UNITED STATES PATENT AND TRADEMARK OFFICE

APPLICATION NO.	FILING DATE	FIRST NAMED INVENTOR	ATTORNEY DOCKET NO.	CONFIRMATION NO.
10/684,765	10/14/2003	Desmond J. Latouche	2224-00300	3350
23505	7590	10/21/2004	EXAMINER	
CONLEY ROSE, P.C. P. O. BOX 3267 HOUSTON, TX 77253-3267			NGUYEN, TRINH T	
			ART UNIT	PAPER NUMBER
			3644

Office Action Summary

DETAILED ACTION

line guide
having aperture

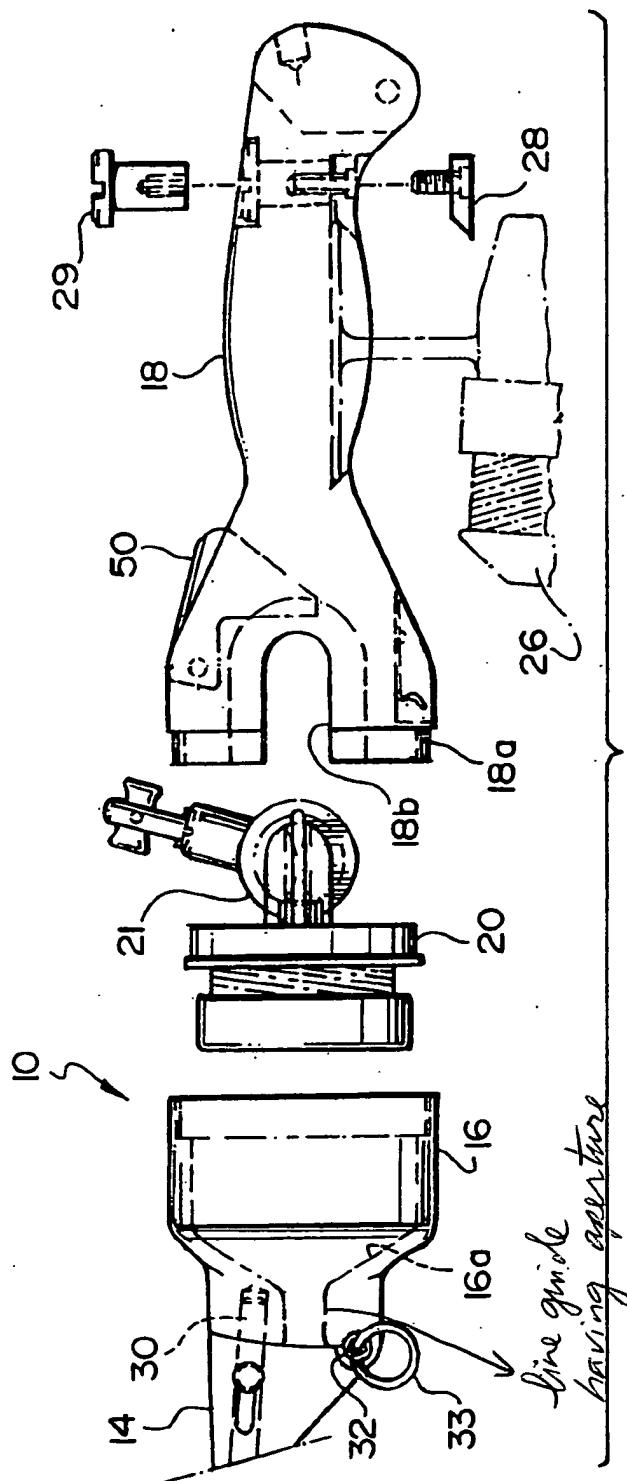
For claim 19, LaTouche further discloses elongated hollow body is provided with a line guide (see attached Figure 2 at the end of this Office Action) having a first aperture for guiding the fishing line. However, LaTouche does not disclose that the fishing line is guided inside the rod. Edwards et al. teach a similar device as that of LaTouche in which Edwards et al.'s device having a line guide (see attached Figure 2 at the end of this Office Action) having a first aperture for guiding the fishing line inside the rod. It would have been obvious to one of ordinary skill in the art at the time the invention was made to have modified the fishing rod of LaTouche so as to include a line guide for guiding the fishing line inside the rod, in a similar manner as taught in Edwards et al., since to do so would eliminate the fishing line from entanglement.
